SUBJECT: Sixth Five-Year Remedy Review Report for Savannah River Site Operable Units with Engineered Cover Systems (U) Aiken, South Carolina (SRNS-RP-2020-00420, Redline Revision 1, June 2021) (Redline Pages) and Savannah River Site's Responses to the Regulatory Comments on the Revision 0 Document, SEMS Number: 00

**SRS Responses to South Carolina Department of Health and Environmental Control Comments on
the Sixth Five-Year Remedy Review Report for SRS Operable Units with
Engineered Cover Systems (U) – Aiken, South Carolina
SRNS-RP-2020-00420, Revision 0, December 2020, SEMS Number: 00
Savannah River Site NPL Site, South Carolina
Comments received March 17, 2021**

**SRS Responses to U.S. Environmental Protection Agency Comments on the
Sixth Five-Year Remedy Review Report for SRS Operable Units with
Engineered Cover Systems (U) – Aiken, South Carolina
SRNS-RP-2020-00420, Revision 0, December 2020, SEMS Number: 00
Savannah River Site NPL Site, South Carolina
Comments received March 24, 2021**

Figure K-2. LLRWDF Units in Relation to MWMF Units

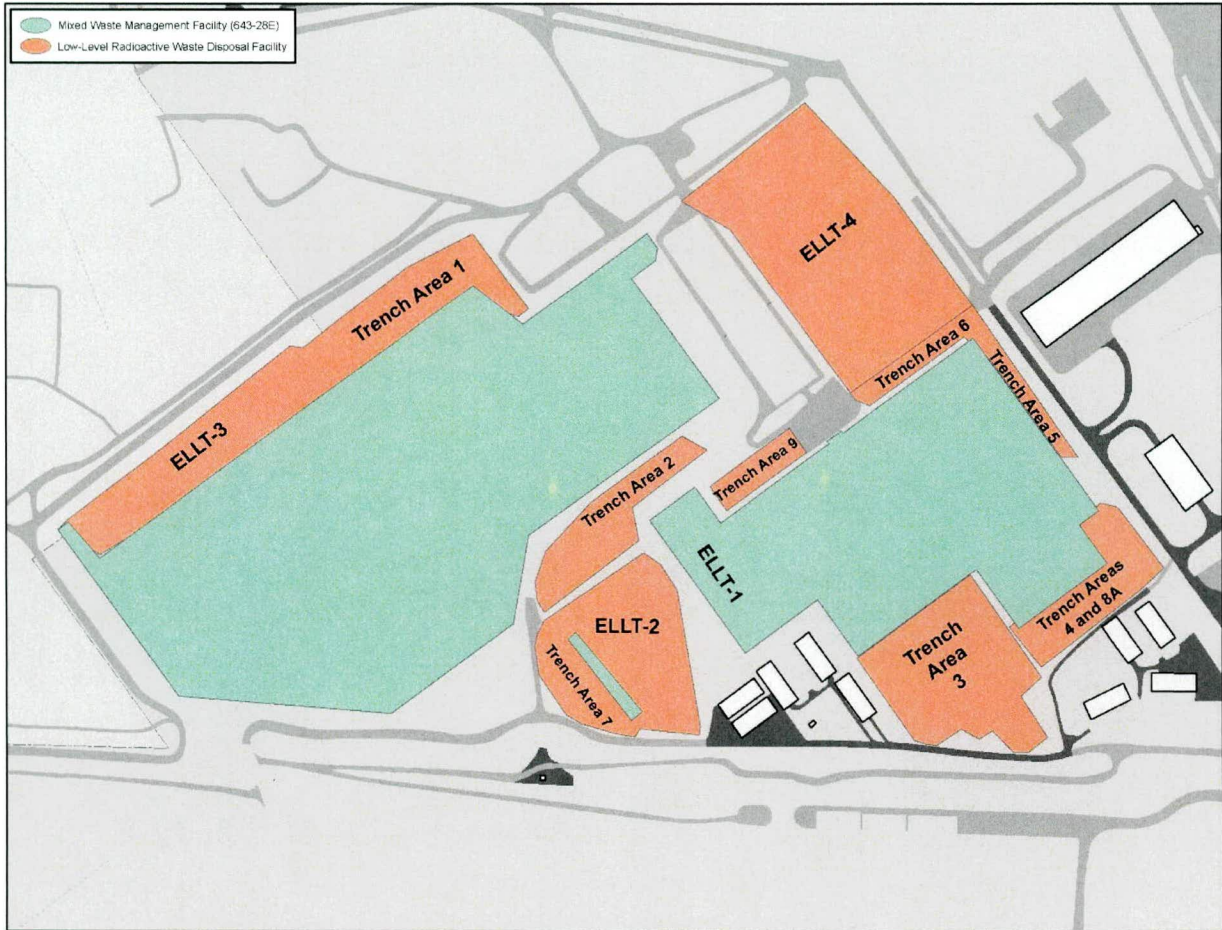
1. Appendix K, Remedy Implementation, page K-5. The last paragraph of this section states that “Later in 1994, portions of the RCRA LLRWDF 5.3-hectare (13-acre) geosynthetic cover system was tied into the MWMF cover system.” The specific portions of the LLRWDF that is tied into the MWMF cover system needs to be identified. Changes in either facility could impact the other.

“...Later in 1994, portions of the RCRA LLRWDF 5.3-hectare (13-acre) geosynthetic cover system was tied into the MWMF cover system. The LLRWDF closure consisted of twelve discrete areas (i.e., ELLT-2, ELLT-3, ELLT-4, and Trench Areas 1 to 9 [Figure K-2]). The MWMF small cap was covered by the ELLT-2 and Trench Area 7 cover system. ELLT-3 and Trench Areas 1, 3 to 6, and 8 were integrated into the MWMF cover system (WSRC 1999b).”

Figure K-2 (attached) will be updated to show the location of the twelve LLRWDF closure areas. Section XII, Documents Reviewed, will be updated to add the WSRC 1999b reference.
